## Your Comment on the Delmore application

Thank you for referring the Delmore fast-track consent (**the Project**) to Auckland Transport (**AT**) for comment. AT is a Council-Controlled Organisation and the Road Controlling Authority for the Auckland region (excluding the State Highway network). AT has the legislated purpose to contribute to an 'effective, efficient and safe Auckland land transport system in the public interest'<sup>1</sup>. In fulfilling this role, AT has an interest in the Project as Road Controlling Authority and as an asset owner.

Beca has been engaged by Auckland Transport (AT) to provide a review of transportation matters in regard to the proposed residential development at Russell Road and Upper Ōrewa Road, Ōrewa (the Delmore application). The application is being progressed under the Fast Track Approvals Act (FTAA).

Figure 1: NOR 6 Designation Boundary<sup>3</sup> and Section within the Delmore Application Highlighted Indicatively

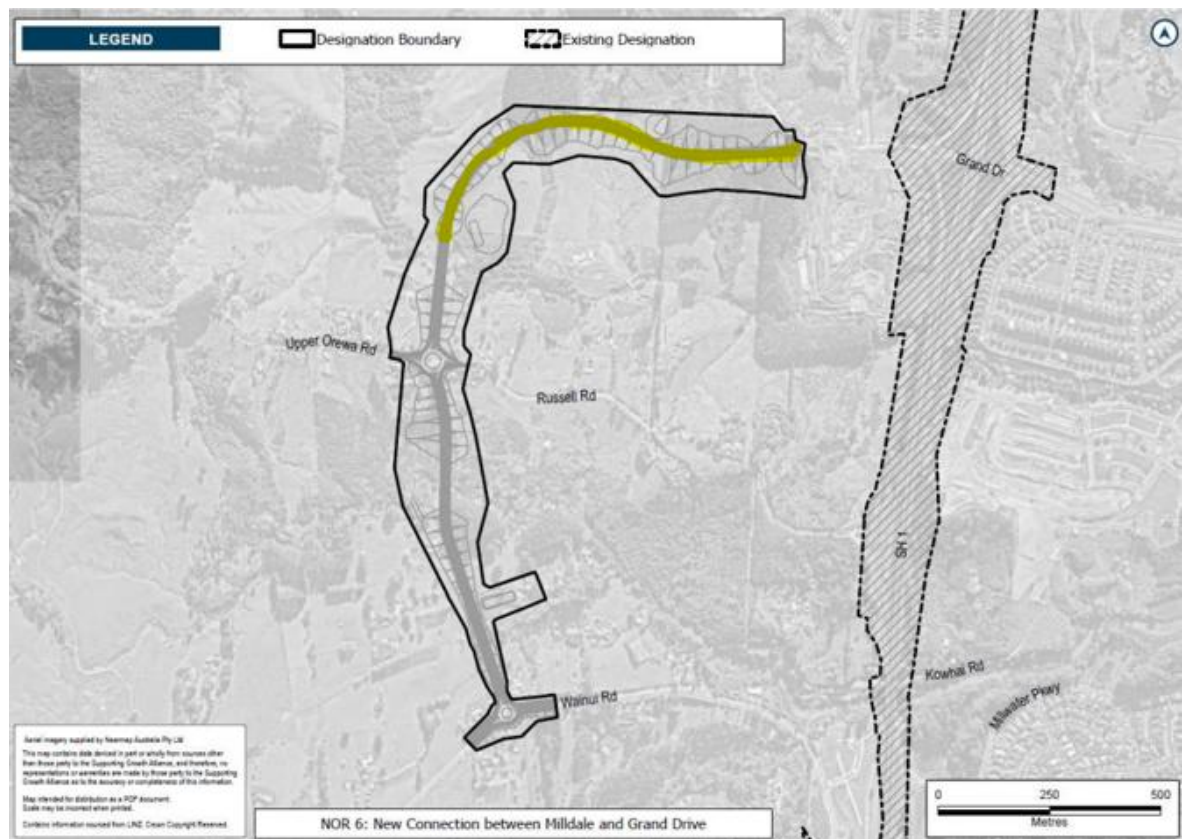
A portion of the NoR 6 designation crosses through the applicant site, and the applicant proposes to construct this section of the road. The following image shows the full NoR 6 designation and the section that would be constructed as part of this application highlighted in yellow.

There is no timeframe for construction of the remaining section of road enabled by NoR 6 outside of this application. The SGA considered a full build out (completion) scenario for the North growth area to be “2048 +”, i.e. meaning development and supporting infrastructure was anticipated to occur sometime beyond 2048, with timing now assumed to be 2050 or later in line with the updated Future Development Strategy. Although that does not mean that individual projects will not be delivered ahead of this time.

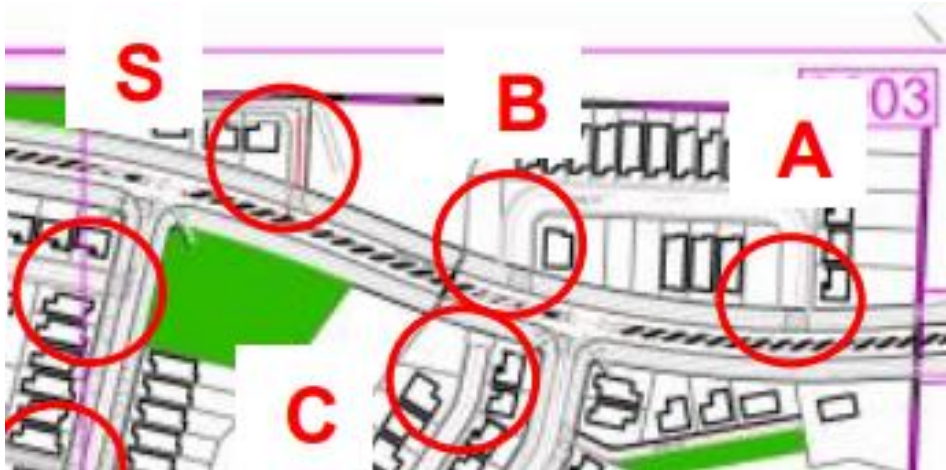
The applicant site layout appears to avoid driveways directly on the NoR 6 road, which is expected for an arterial corridor. A condition to this effect is recommended.

There are however, four Joint Owned Access Lots (JOAL) with direct connection to the NoR 6 road, all within a relatively short section. As shown in the image below (intersections S,B,C,A). There are also two local road intersections in this area.

A proliferation of turning movements in this area, considering the local road intersections as well as the JOALs, will impact on movement along the corridor and could compromise safety, especially for pedestrians and cyclists.

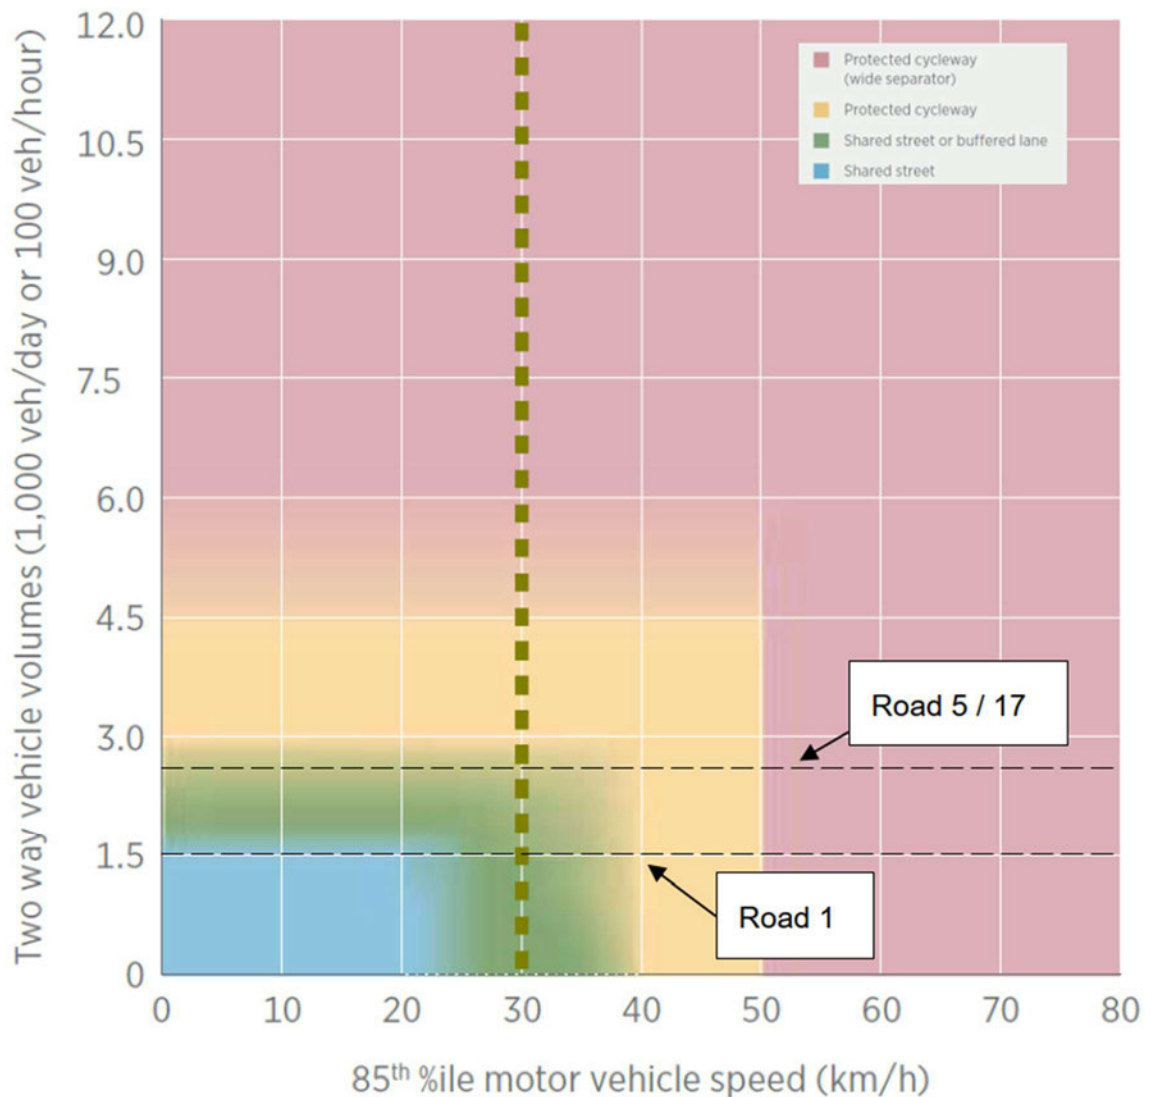
44. The proposed road network lacks the normal road hierarchy as it only has local roads and the NOR 6 arterial road. A more typical road hierarchy includes collector roads which function to collect and distribute traffic between local roads and arterial roads.
45. Appendix 13 of the application included an indicative structure plan for Wainui-Orewa with future collector roads indicated. The structure plan collector roads correspond with the following roads in the Civil drawings and ITA;
  - a. Road 1
  - b. Road 17 Upper Orewa Rd to Road 14 only
  - c. Road 14 from Road 17 to Road 05 only.
  - d. Road 05

46. I consider that the locations of the collector roads indicated in the indicative structure plan are appropriate for the proposal.
47. I also consider that these roads should be designed to allow them to be used as future bus routes. It should be noted that while bus routes and collector roads have many of the same design features they are not the same and Auckland Transport often operates bus services on roads otherwise considered to be local roads, but when this occurs the roads need to be designed to accommodate buses.

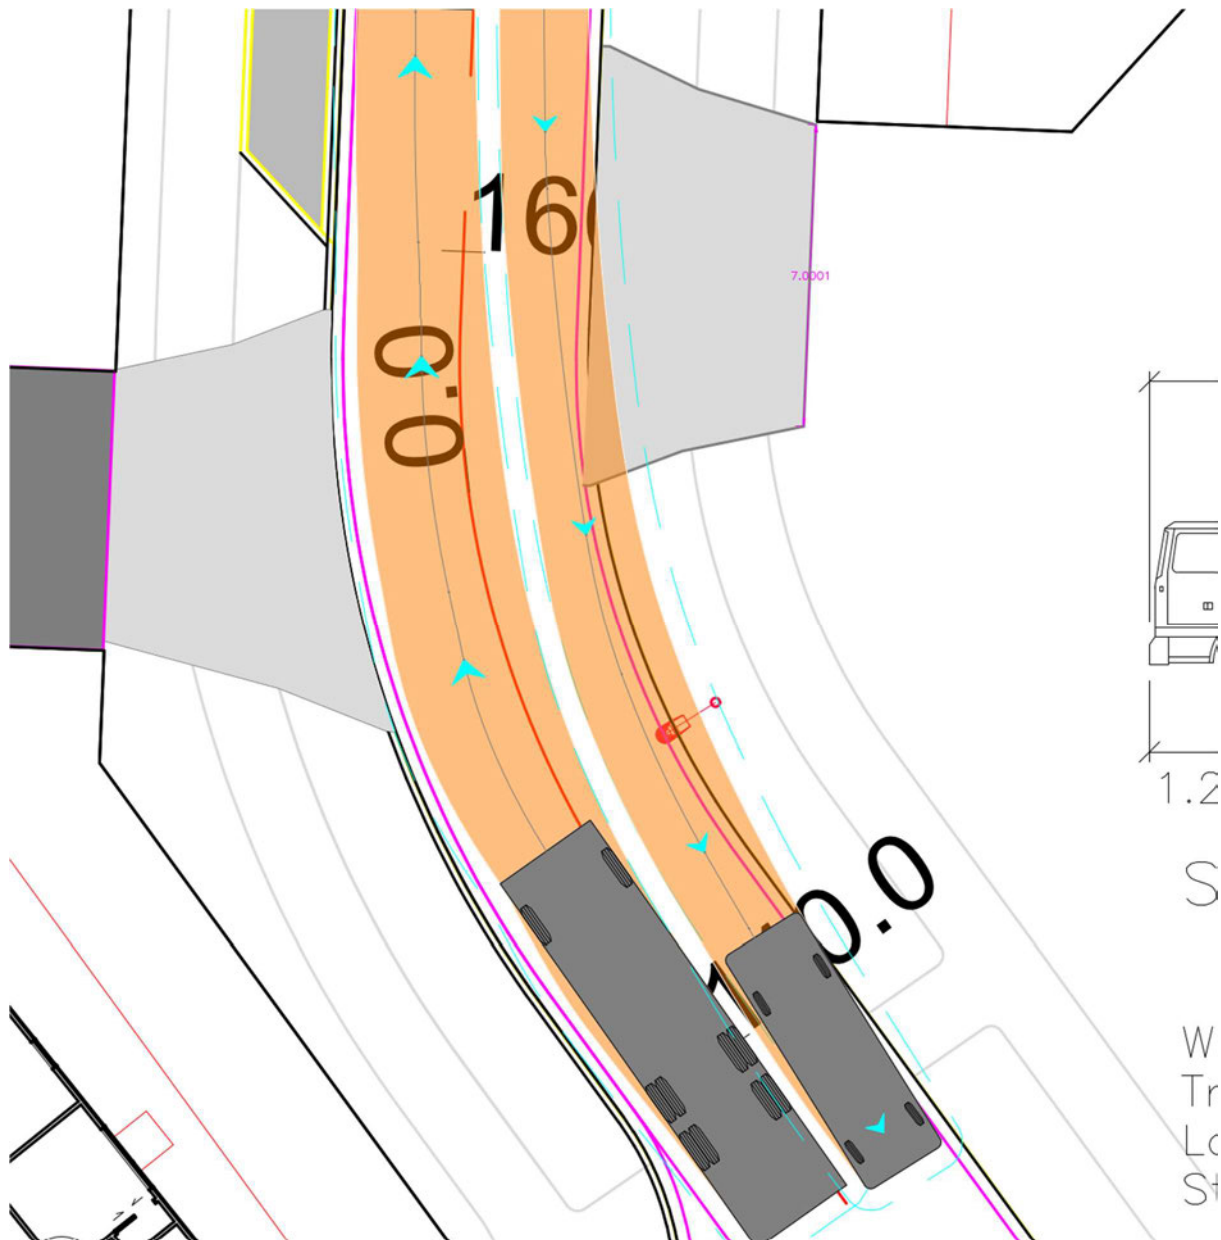
1. Road 01 / NOR 6 Road
  2. Road 05 / NOR 6 Road
  3. Road 05 / Road 14
  4. Road 14 / Road 17
72. These intersections correspond with the collector roads / future bus routes which I discussed earlier in the memorandum. By providing roundabouts at these intersections delays to buses at intersections can be limited, particularly when turning in or out a side road off the NOR 6 Road. This helps provide faster and more reliable travel times for public transport users and helps mitigate the car dependency related effects of the proposed development.

73. The NOR 6 drawings do not show roundabouts on the NOR 6 road within the development but this is because none of the site road intersections were shown. It was expected that the developer would design appropriate intersections to connect onto and this did not limit the type of intersection which could be used to preclude roundabouts.

74. All intersections should be designed for vehicle tracking to AT Engineering Design Code Urban and Rural Roadway Design. This includes but is not limited to bus tracking as all these roads are potential bus routes.

75. The horizontal curve in Road 05 should be straightened out, the curve shown in the drawings increases travel distance, causes visibility issues from driveways, and is a potential loss-of-control run-off-road crash hazard location.
